Brian Ezyk
Sunny Farms Landfill LLC
12500 W Co Rd 18
Fostoria, Ohio 44830
Subject: Sunny Farms Landfill, Seneca County
Letter of Compliance

Municipal Solid Waste Landfill
Inspection Checklist

Settling near cell 2

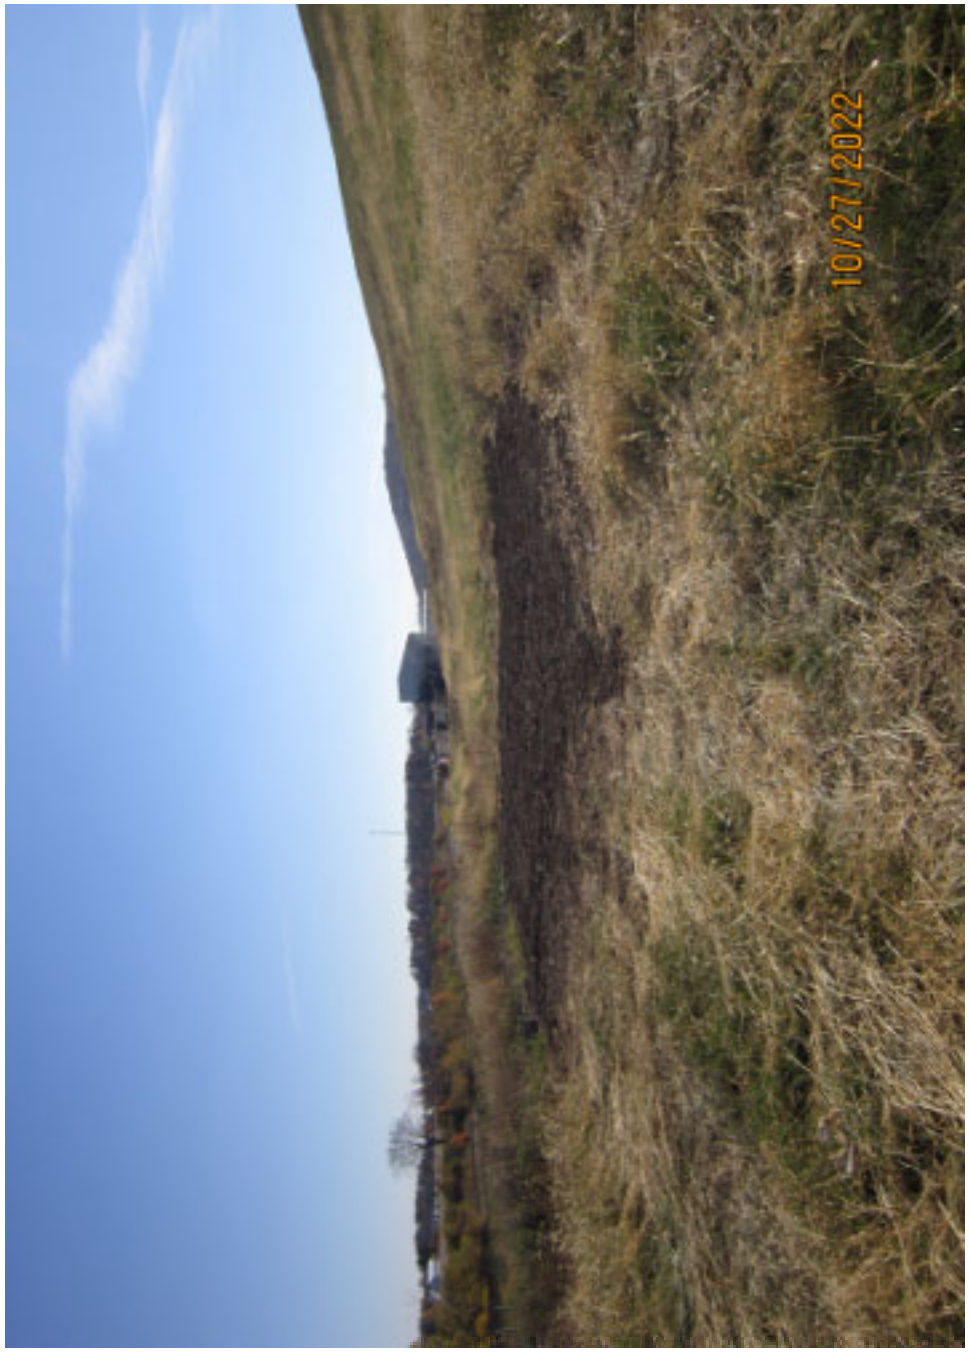
#	Item/Information Section
48	Observed large erosion cut on the SW slope of cell 10 near spine. Cut is ~1 foot in depth, no exposed waste observed. Facility was notified.
56	Alarm on was shown on the SCADA for cell 12, at the display no reading was shown. Facility says it is temporily shut down due to tie in and temp sumps.
48	Cell 2 area recently filled with fresh soil shown in pictures, Area south of that location still has area that appears to be sunken in comparison to surrounding area. Settling may be occuring. Please investigate.

#	General Comments Section
	Broom truck was out cleaning road
	Cover looks good
	Working area small compact and defined. Observed wood material, paper material, tarps and cloth.
	Slope seeding 10-31-2022
	Cell 2 area recently filled with fresh soil shown in pictures, Area south of that location still has area that appears to be sunken in comparison to surrounding area. Please investigate.
